Potomac Yard (CDD #10) Development Applications

Potomac Greens (Parcel A)
Development Special Use Permit
#2002-0026
Encroachment #2003-0002
Street Name Case #2003-0002

City of Alexandria
Planning Commission
April 1, 2003

Docket Item #7
DEVELOPMENT SPECIAL USE PERMIT #2002-0026
ENC #2003-0002
STREET NAME CASE #2003-0002
POTOMAC GREENS-Potomac Yard PARCEL A

Revised Open Space Plan:

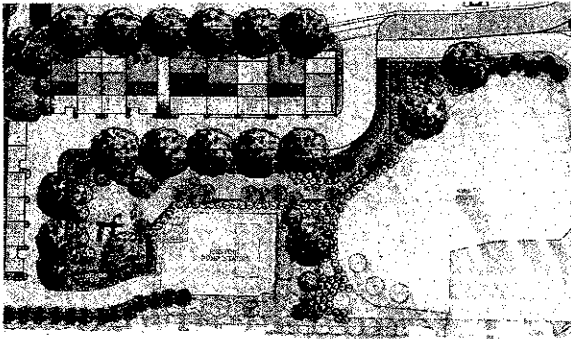
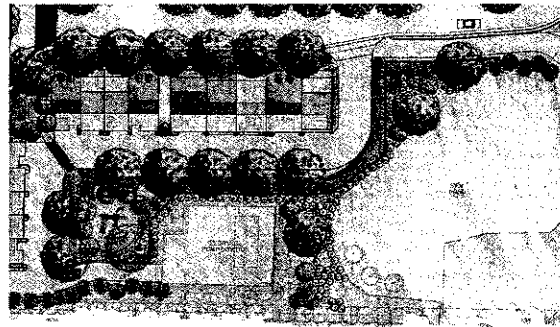
The applicant revised the plan to provide an additional 6,063 sq. ft. of open space on the Potomac Greens Parcel-A. The additional open space proposed by the applicant at the April 1, 2003 hearing increased the amount of landscape area within the open space/buffer area between Potomac Greens and Old Town Greens from 17,888 sq ft to 23,951 sq ft, not including the stormwater management pond, and sewer pumphouse and surrounding fenced area. The plan was also revised to exclude the approximately 1,000 sq.ft. area on the southern portion of the site within the WMATA slope easement and areas such as the triangular areas around the traffic circle that were previously included in the open space tabulation. The additional open space was obtained, not by eliminating units, but by decreasing the depth and width of several of the units.

The additional depth of this open space area was accomplished by reducing the depth of 7 units (lots 15 - 21) from 56 ft. to 42 ft., and decreasing the width of the alley adjacent the pumphouse from 24 ft. to 22 ft. While the depth of the units for these lots decreased the number of units increased from 7 to 9 units in this string. A concern raised by the introduction of the additional units is the proposed setback between the group of five and four units as discussed in more detail below. The largest amount of the additional open space is located within the southern open space/buffer area adjacent to Old Town Greens. The largest consolidated portion of this area now measures approximately 40 ft. x 130 ft., exceeding the minimum dimensions of 40 ft. x 80 ft. for neighborhood parks in Parcel A.

The applicant has also revised the shape and size of the mews to meet a minimum area of 3,200 sq ft. While the revised size of the mews is approximately 43' by 75' and 44' by 73', rather than the Guideline stated 40' by 80', Staff believes the overall size is consistent with the intent of the Guidelines.

*Plan With Reduction of 5 Units
Adjacent to Old Town Greens*

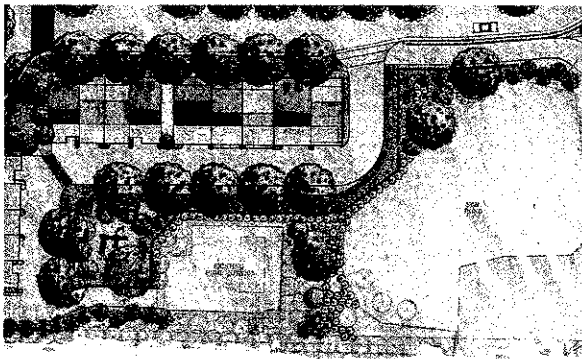
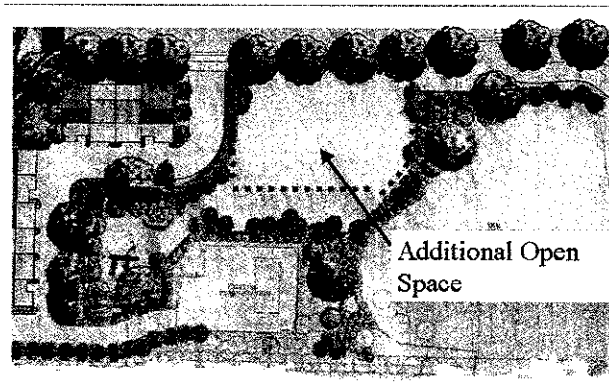
In the January plan submitted by the applicant, lot coverage was estimated to be approximately 94%. With the addition of 6,062 sq ft to the southern open space area and the corresponding decrease in building footprints of the revised April 1st plan, the applicant has reduced overall lot coverage to approximately 90 % of the originally proposed building lot area. One of the questions raised by Commission is whether the elimination of several units (five units) on the southern portion of the site would bring the plan into greater compliance with lot coverage. The elimination of five units in this location would significantly increase the amount of open space and the opportunity for

This increase in open space and corresponding decrease in building footprints would result in a building coverage of 88% in relation to the originally building lot area.

If the Planning Commission recommends elimination of the units, Staff recommends against eliminating units adjacent to Potomac Greens Drive, that provide a screen for the pumping station and help to integrate the proposed development with the adjoining Old Town Greens development. In addition to reducing the relative lot coverage, the elimination of the units allows a significant amount of additional open space and landscaping on the southern portion of the site. If the units are to be eliminated to bring the plan into greater compliance with the recommended lot coverage, staff is recommending the elimination of the five units depicted above. The elimination of these units would increase the amount of open space, landscaping and buffer between the proposed development and the existing Old Town Greens development.

Visibility from the Parkway:

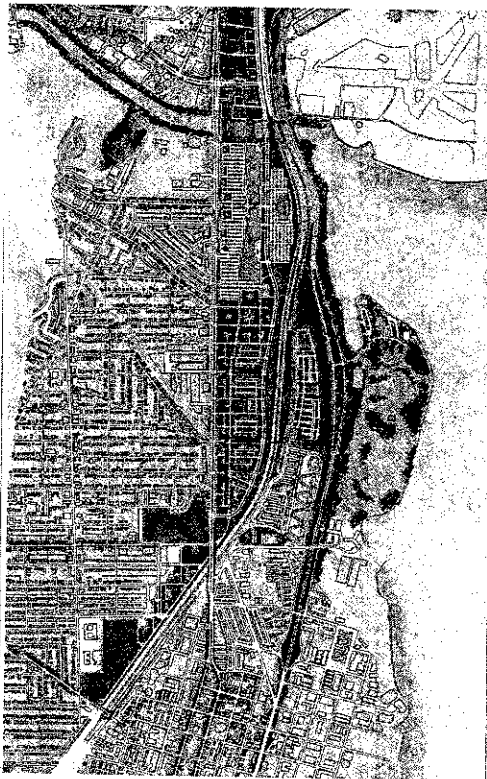
While there are a considerable amount of trees between the Parkway and the proposed townhomes, the trees are primarily deciduous and the proposed buildings will be visible during the months when these trees lose their foliage. To mitigate the visibility of the proposed units from the Parkway, Staff is recommending a considerable amount and variety of deciduous and evergreen trees, although portions of the units, especially the upper portions of the units and roof lines, will be visible from the Parkway.

Potomac Greens block

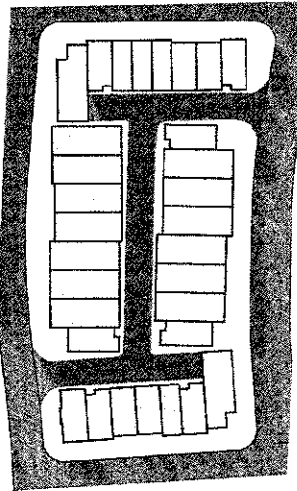
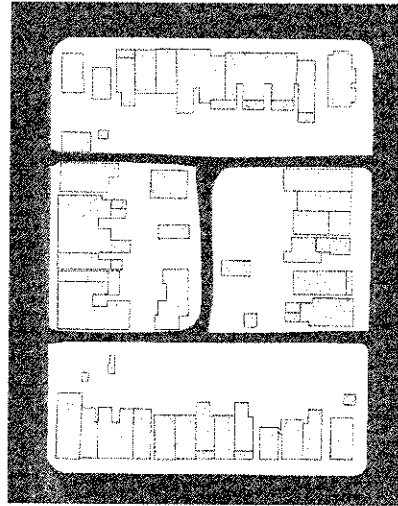
Lot Coverage

Alternate Emergency Vehicle Easement
(shown in red)

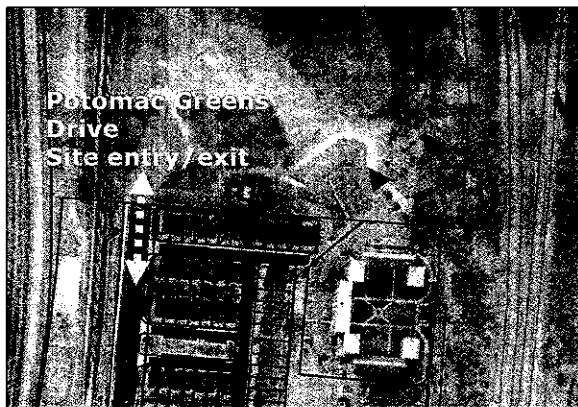
The Potomac Greens site creates a unique accessibility challenge for public safety agencies because, to access the site, the only point of entry, Potomac Greens Drive, requires crossing an active rail at Slaters Lane that could be blocked by passing rail cars during an emergency. The rail crossing is owned and operated by the Norfolk Southern Railroad for coal deliveries to the adjacent Mirant Power Plant and boxcar deliveries to Robinson Terminal at the City's waterfront.

This rail crossing is the main spur for switching operations to both of the above mentioned facilities. Railroad switching operations, by nature, often impede traffic at intersections for prolonged periods of time. During such railroad switching operations, all access to the Potomac Greens site would be cut off for prolonged periods of time. Emergency response crews from Arlington and National Airport will respond as available to calls from Alexandria; however, in the event of a fire, medical emergency or crime in progress, any delays in response could be detrimental to the community.

B. Variation in Building Heights:

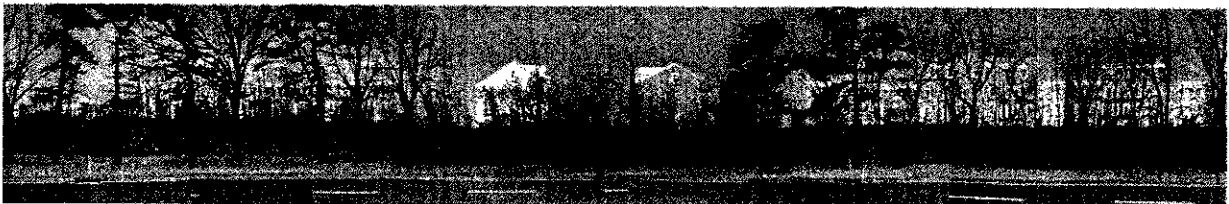
As previously discussed these small blocks provide more openness and porous circulation and break the continuous rows of townhomes providing considerable public benefit. However accommodating the townhomes on these smaller blocks increases the lot coverage and perceived density within each block. To address the Staff concerns of lot coverage, the applicant has removed 17 units in the development, reduced unit heights, and refined the project plan with additional green spaces. Staff is further recommending that the footprint of five units be reduced to provide additional visual relief, open space and landscape areas from the adjoining public streets. With these changes to the five units in addition to the previous reductions to the project density, Staff believes that the lot coverage and perceived density of the project in combination with additional variation in heights as recommended below will significantly reduce the perceived mass and will create lot coverage conditions that are consistent with the intent of the Guidelines.
